ADDENDUM NUMBER 1

| NOTIFICATION DATE: | SOLICITATION TITLE: | SOLICITATION | BID OPENING DATE & TIME: | l |
|--------------------|-----------------------------------|--------------|--------------------------|---|
| | Gulf Shore Boulevard North | NUMBER: | | |
| 7/20/2022 | Outlot "E" Seawall | 22-040 | 7/29/2022 2:00PM | |
| | Replacement - ITB | | 2.001 W | |

Exhibit B - Venetian Yacht Club North Electrical & Water Plan

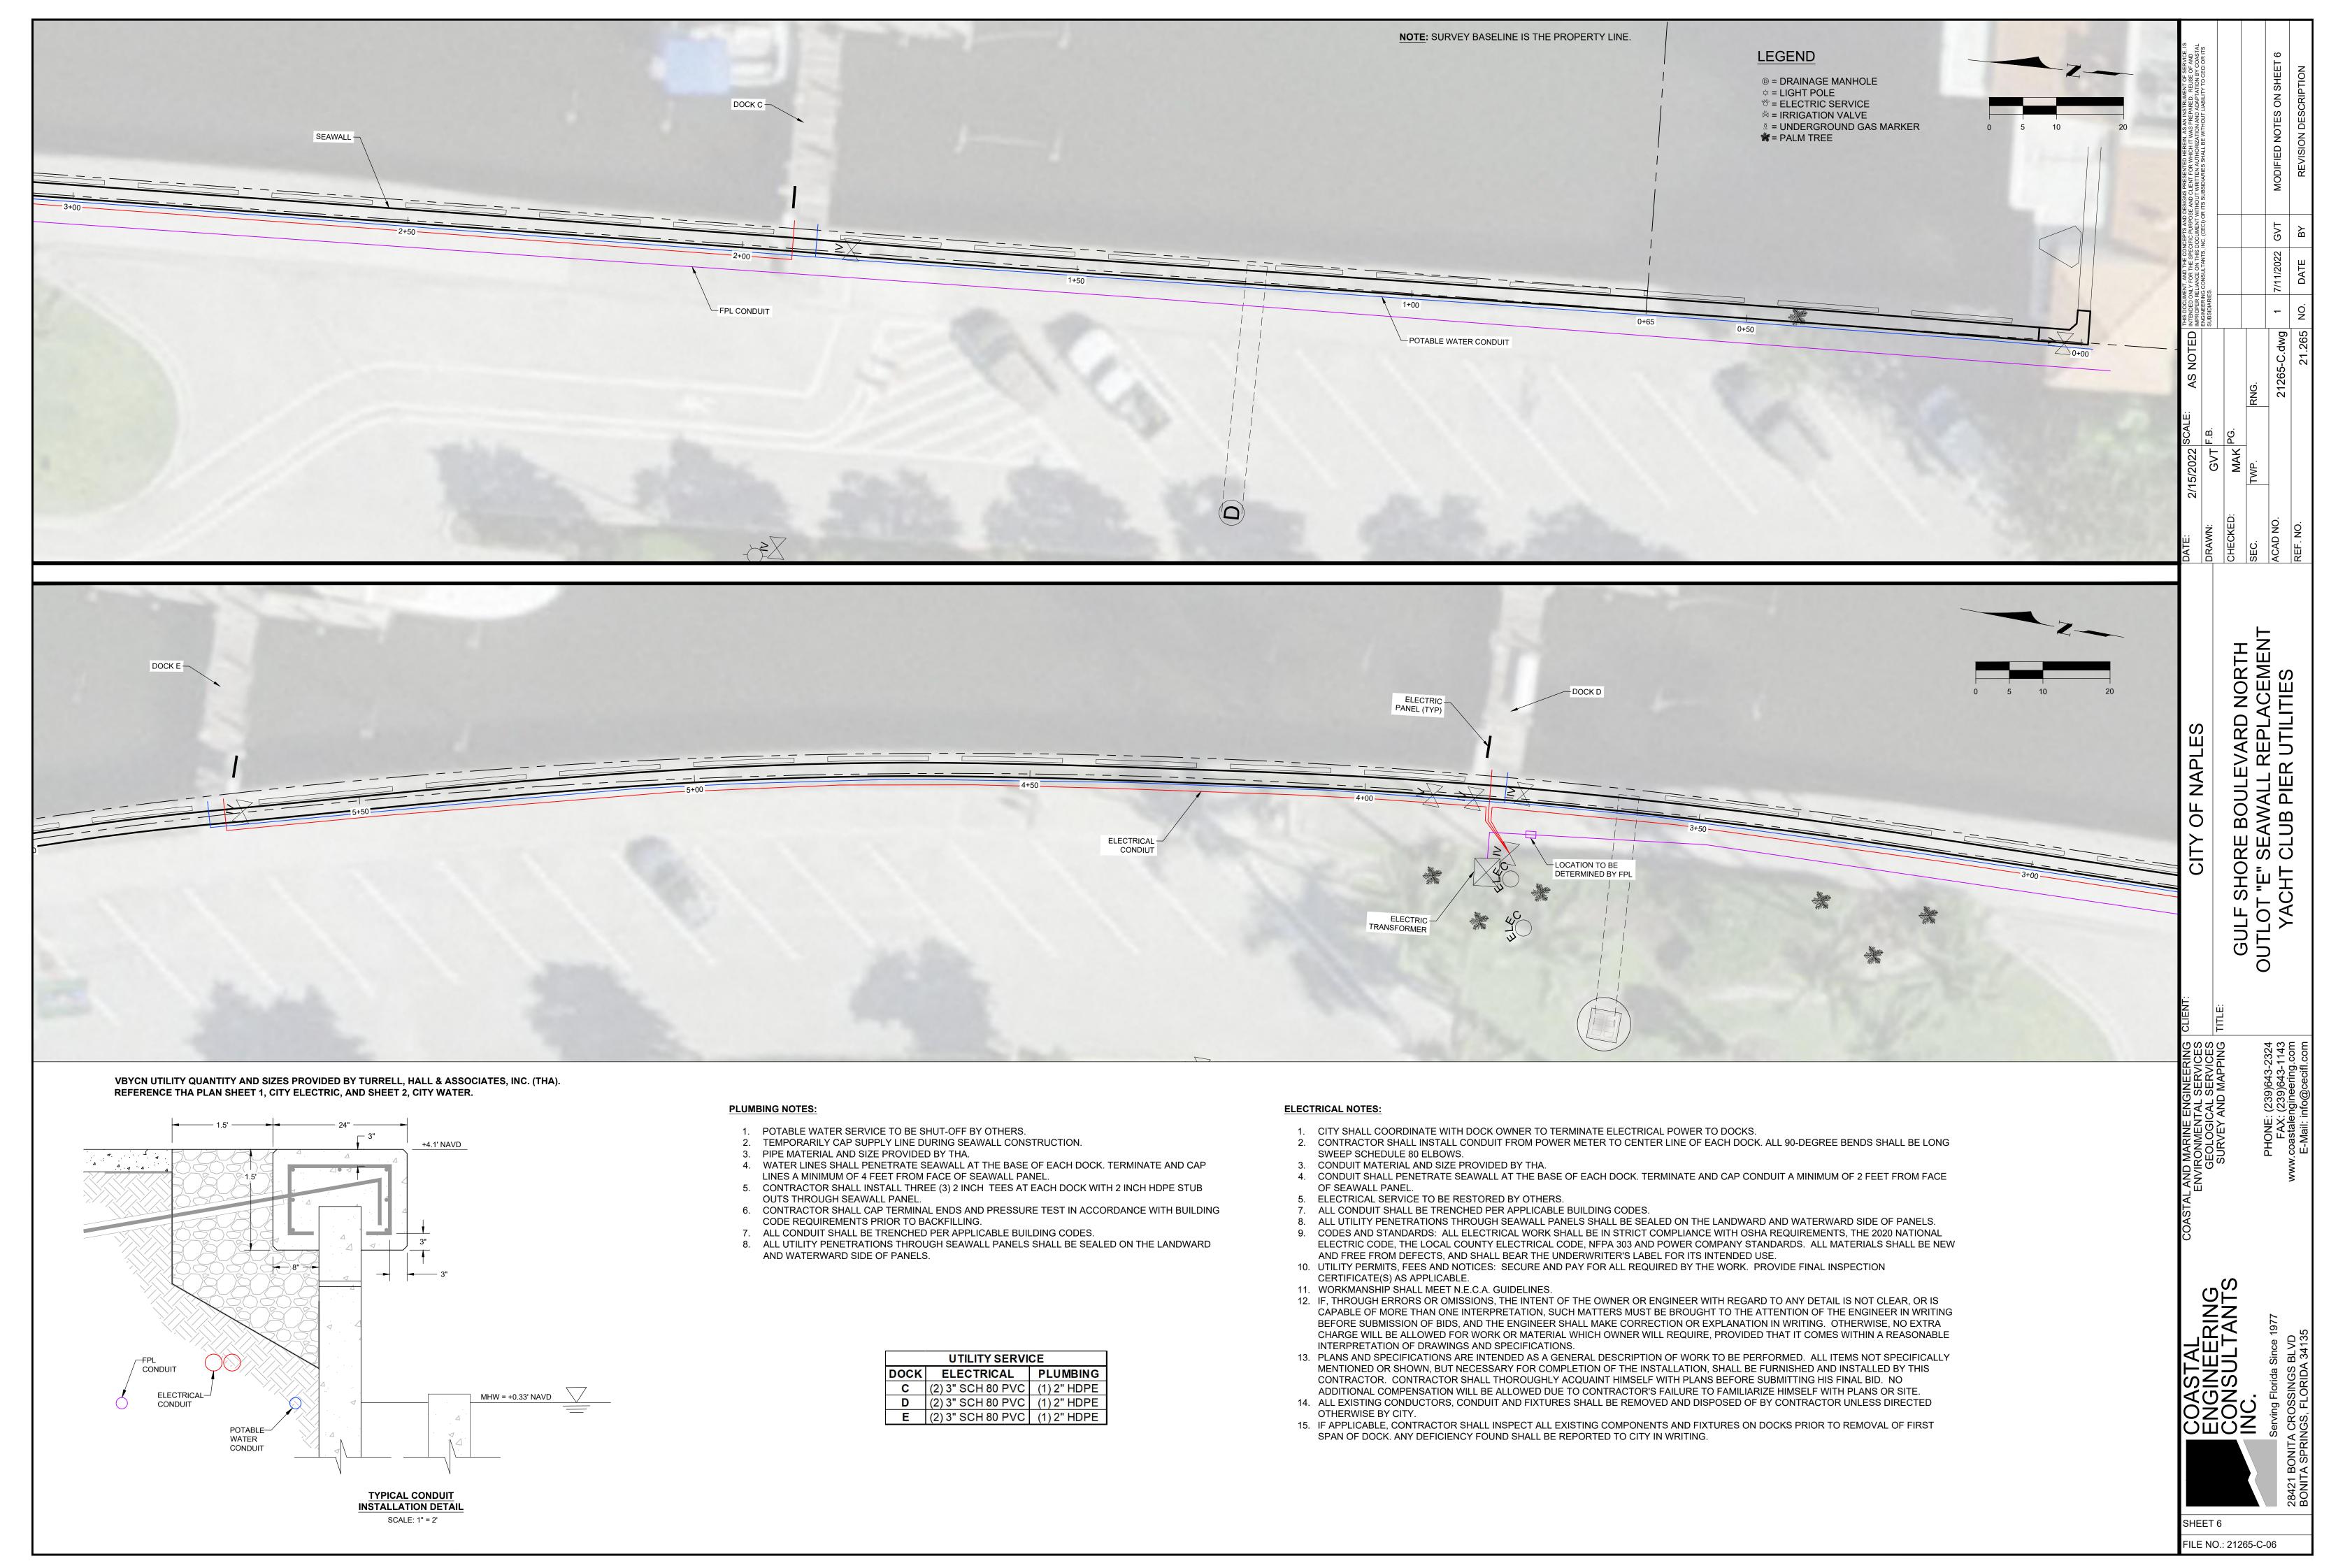
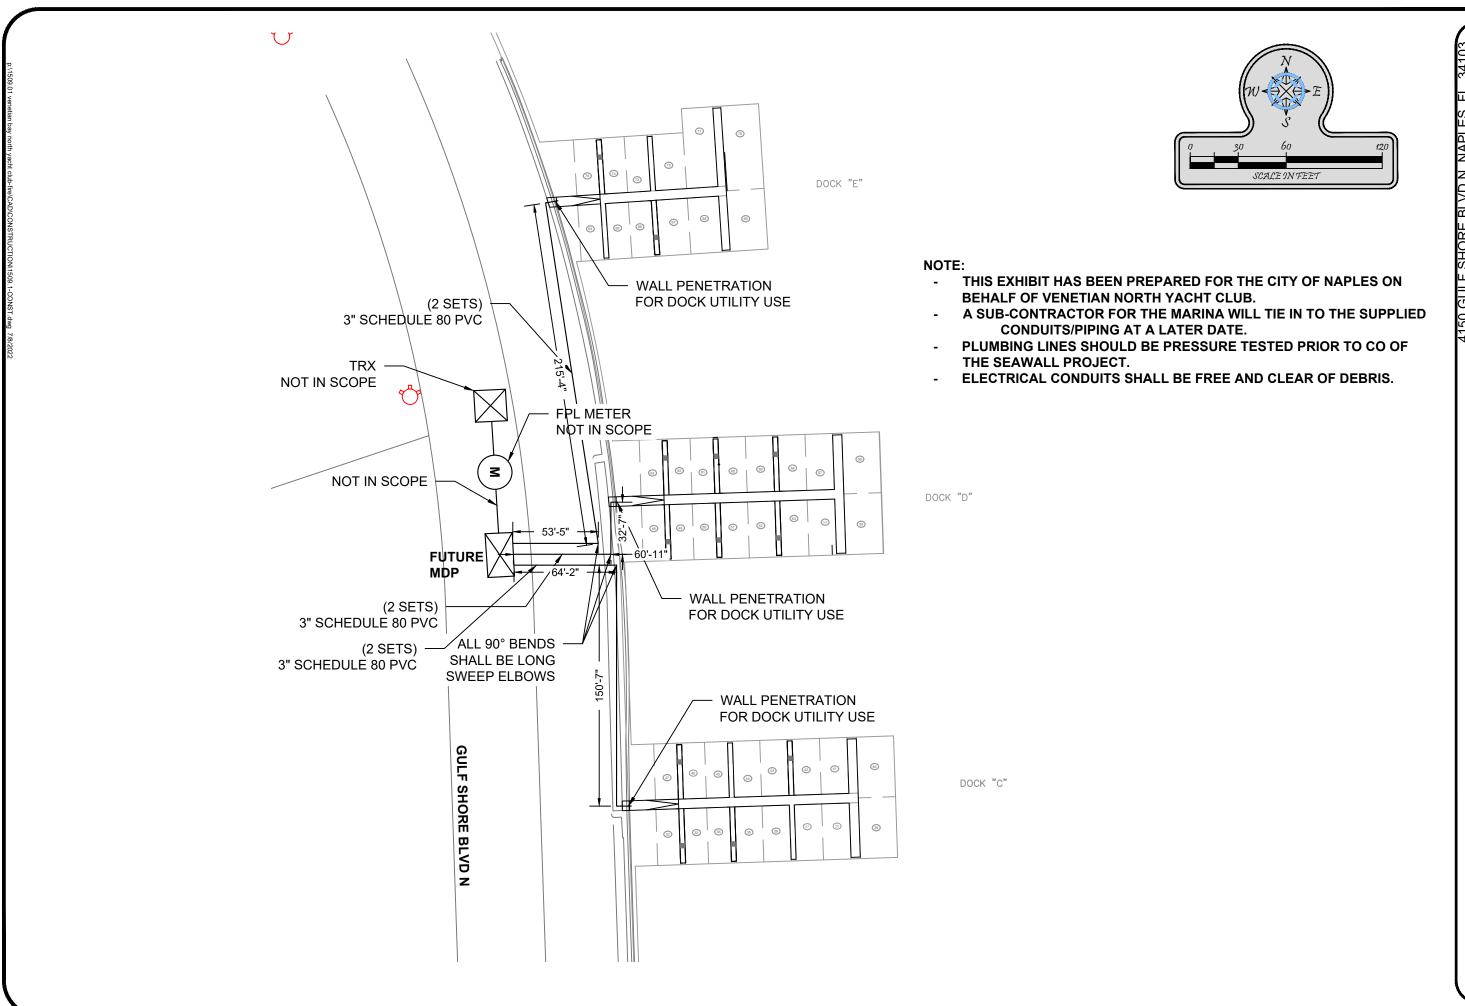
- 1. Attached Exhibit A is a REVISED Sheet #6 of the bid document.
- 2. Attached Exhibit B is the Venetian Yacht Club North electrical and water plan.
- 3. For bids to be deemed responsive a complete bid schedule inclusive of the Optional Bid Items 7.1 through 7.4 must be submitted. Please reference Optional Bid Item Notes on Plan Sheet 3 for additional information. Bidders must complete the bid schedule inclusive of the Optional Bid Items 7.1 through 7.4 or the bid submittal will be rejected.

Exhibit B - Venetian Yacht Club North Electrical & Water Plan **CLUB NORTH** DOCK "E" SCALE ON FEET HDPE 2" TEE THROUGH YACHT **NEW SEAWALL TO** SERVICE DOCK W/ 4FT BEYOND FACE INSTALL 2" HDPE (TYP. UNO) FROM OF SEAWALL FOR NOTE: DOCK D TO DOCK E **FUTURE CONNECTION** - THIS EXHIBIT HAS BEEN PREPARED FOR THE CITY OF NAPLES ON BAY BEHALF OF VENETIAN NORTH YACHT CLUB. A SUB-CONTRACTOR FOR THE MARINA WILL TIE IN TO THE SUPPLIED CONDUITS/PIPING AT A LATER DATE. **VENETIAN** PLUMBING LINES SHOULD BE PRESSURE TESTED PRIOR TO CO OF THE SEAWALL PROJECT. ELECTRICAL CONDUITS SHALL BE FREE AND CLEAR OF DEBRIS. DOCK "D" 61) HDPE 2" TEE THROUGH NEW SEAWALL TO SERVICE DOCK W/ 4FT BEYOND FACE OF SEAWALL FOR FUTURE CONNECTION **GULF SHORE BLVD** INSTALL 2" HDPE (TYP UNO) FROM DOCK C TO DOCK D 1/4 TURN SHUTOFF 2" BACKFLOW **PREVENTER** DOCK "C" 37) 39 HDPE 2" TEE THROUGH NEW SEAWALL TO SERVICE DOCK W/ 4FT BEYOND FACE OF SEAWALL FOR FUTURE INSTALL 2" HDPE (TYP UNO) FROM TO POTABLE WATER CONNECTION SOUTH TERMINATION OF CITY **CONNECTION TO BE 24"** PROPOSED SEAWALL PROJECT TO DOCK C **BELOW GRADE** 2" HDPE MAIN PIPE **BACKFLOW PREVENTER DETAIL** N.T.S
